RAIL YARD CSO RELOCATION PROJECT, BID NO 946
CHANGE ORDER NO. 2 - WHALES TOOTH PARKING LOT

ELECTRICAL DETAILS - 3

FARE COLLECTION SYSTEM DETAILS

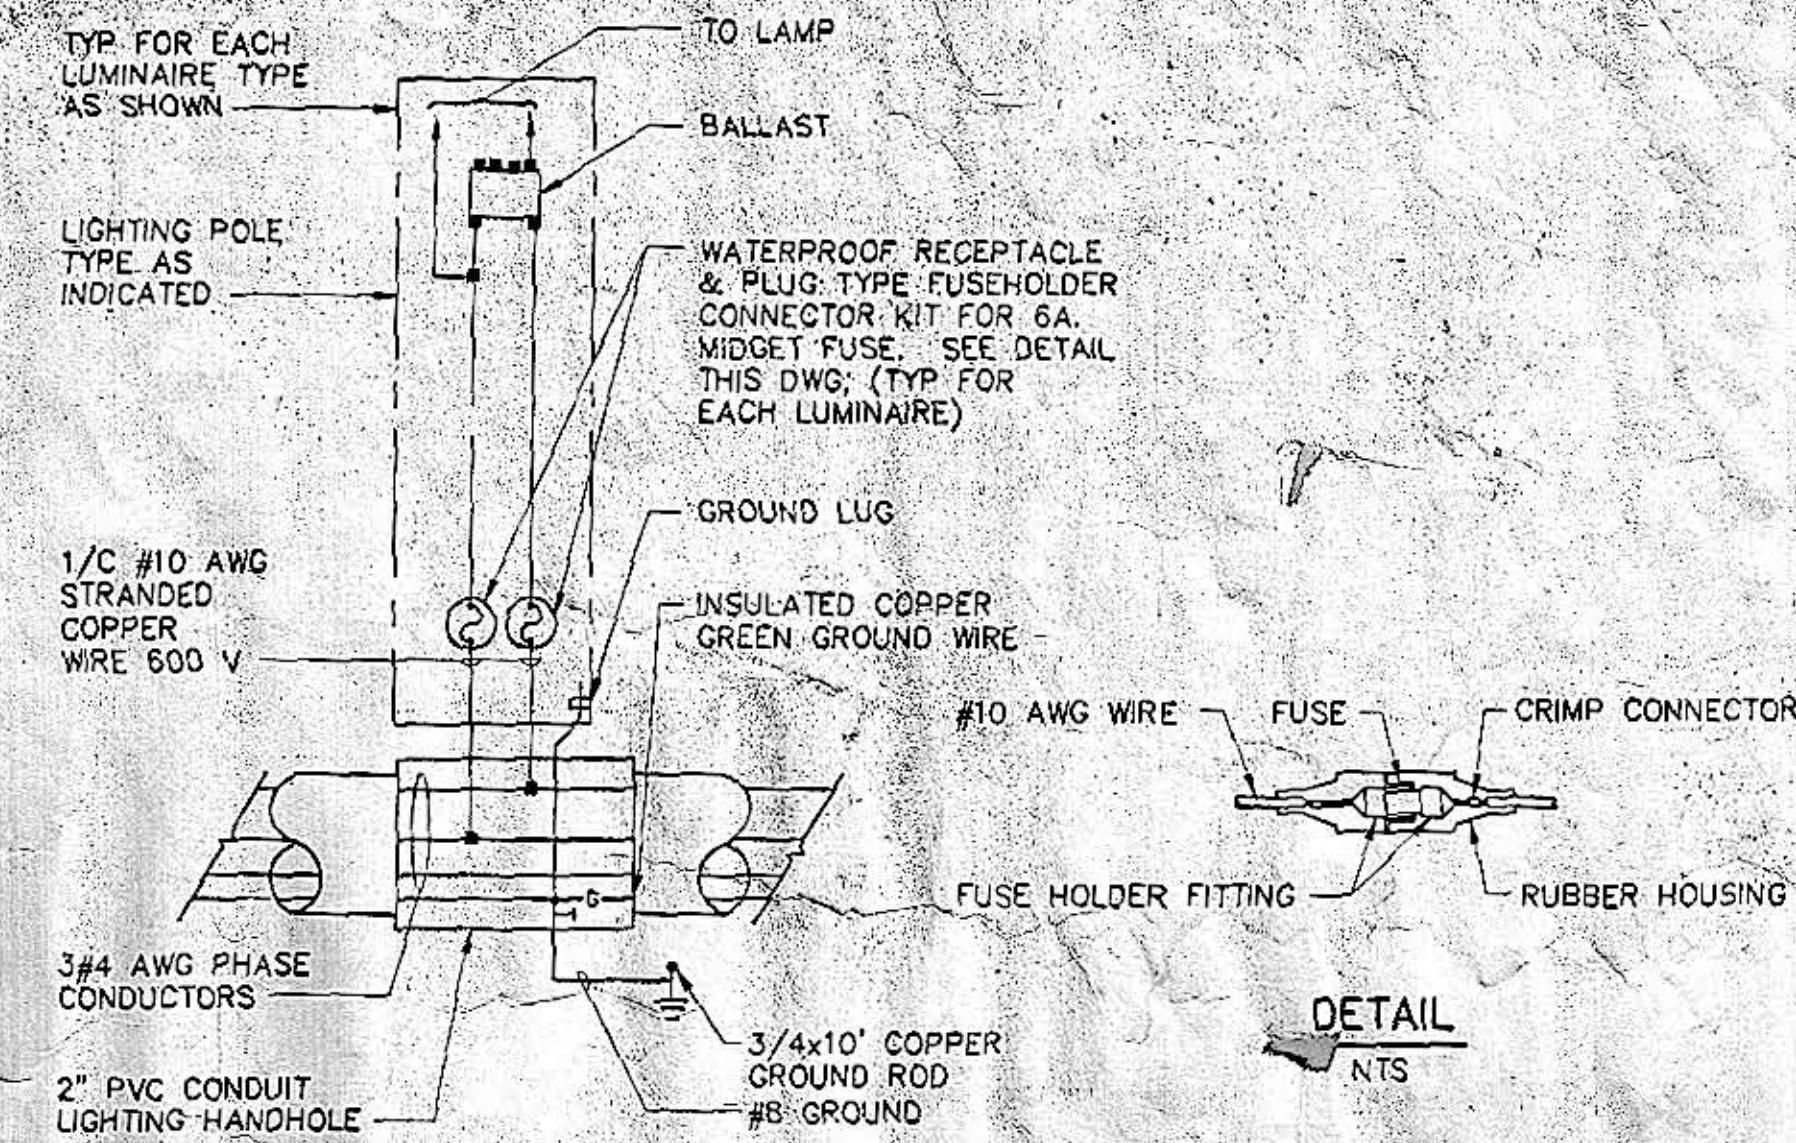
1-4 to Verizon mtn note as per Paul Bourke

1/2" = 1'		DG DG PK		
	REVISED FARE COLLECTION EQUIPMENT, ADDED SPARE 2" TELEPHONE CONDUIT				
	ISSUE DATE	DESCRIPTION	BY: CHD: APP	PROJECT MANAGER	
SCALE: AS NOTED		DRAWN BY:	DESIGN BY:	CHECK BY:	PLAN NO.
DATE: 10-03-03		WD	MC	PK	SHEET E-5

- 1 THE BOOTH, EQUIPMENT, LOADCENTER, ETC. LAYOUT SHOWN IS ONLY FOR GENERAL INFORMATION. THE EXACT LAYOUT WILL DEPEND ON THE FARE COLLECTION SYSTEM SUBMITTED AND APPROVED. COORDINATE ALL ELECTRIC WORK WITH THE FARE COLLECTION SYSTEM MANUFACTURER.
- 2 100A FARE COLLECTION BOOTH LOAD CENTER PROVIDED WITH BOOTH.
- 3 4 #3& 1 #8GND IN 2" PVC FEEDER CONDUIT FROM SERVICE CABINET ENCLOSURE.
- 4 TELEPHONE SERVICE BACKBOARD. PROVIDE 2'X2'X3/4" PLYWOOD BACKBOARD FOR TELEPHONE SERVICE DEMARCATION & DISTRIBUTION.
- 5 2" CONDUIT AND 2" SPARE CONDUIT CONNECTION FROM VERIZON SERVICE PEDESTAL TO TELEPHONE BACKBOARD.
